APPLICATION

FOR PERCOLATION TESTING AND SITE EVALUATION

AP 527893

RE: Variance request
18571 Penn Shop Rd
Mt. Airy, Maryland 21771

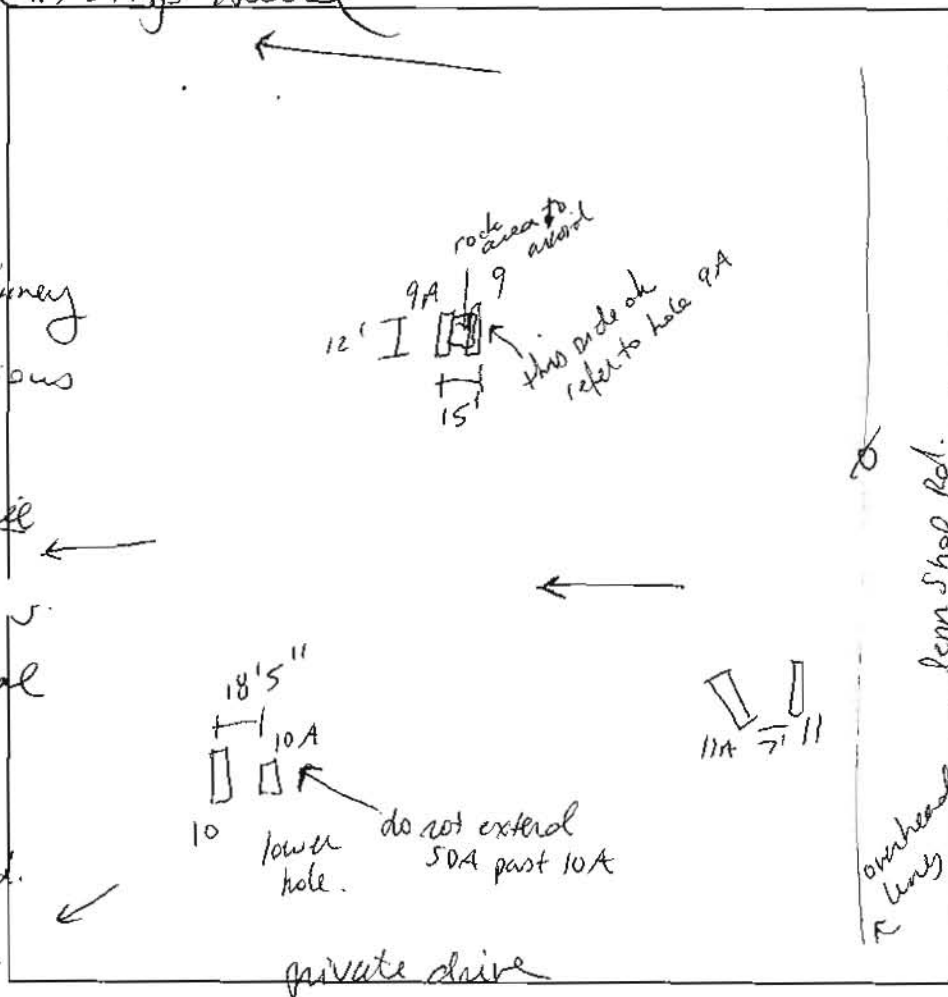
9
brn l dry
brn
fine silt
very dry, hard
sbk 25% channery
2 1/2
light red/brn
silt micaceous
cw 35% channery
phyllite
saponite
downhill
6' 3"
+ 50% channery
phyllite
saponite
uphill
11' refusal

9A
brn l dry
brn
silt dry, hard
sbk
2 1/2
light red/brn
silt
micaceous
35% channery
uphill
6'
45% channery
8'
11' refusal

10/10A
brn
silt dry hard
2'
brn (gray cherty rock)
silt micaceous
40% channery
phyllite
schist
saponite
10'
refusal

11
brn l @ surface
~1/2"
brn
silt very hard
sbk
1 1/2
light red/brn
silt
micaceous
sideward means.
40% channery
refusal 10'

11A
brn l @ surface
~1/2"
brn
silt
very hard & dry
2 1/2
light red/brn
silt
not cemented
35% channery
7'
40% channery
saponite

DATE	TEST #	DEPTH	START	BREAK 1" DROP	STOP 2" DROP	TIME OF 2ND INCH	P/F/H
8/28/08	9	3' 8" / 11'	9:15	10:00	next to 1st inch		F
	10	3' 7" / 10'	10:04	10:39	next to 1st inch		F
	"	4' 1/2	10:45	10:57	11:27	water just above tip	-
	10A	4'	12:03	No movement			
		5'	12:22	12:29	12:40	11	P
	9A	4' 1/2 / 11'	10:30	10:50	11:20	30	P
	11	5' / 10'	9:33	10:03	10:35		F
	11A	5' / 10' 5"	11:05	11:09	11:12	3	P
	10	5'	11:37	12:23	next to 1st inch		F

* 10A dug to see if rock
'decanted, hole exists to dip but overall
consistent with #10 w/ lesser degree of rock.
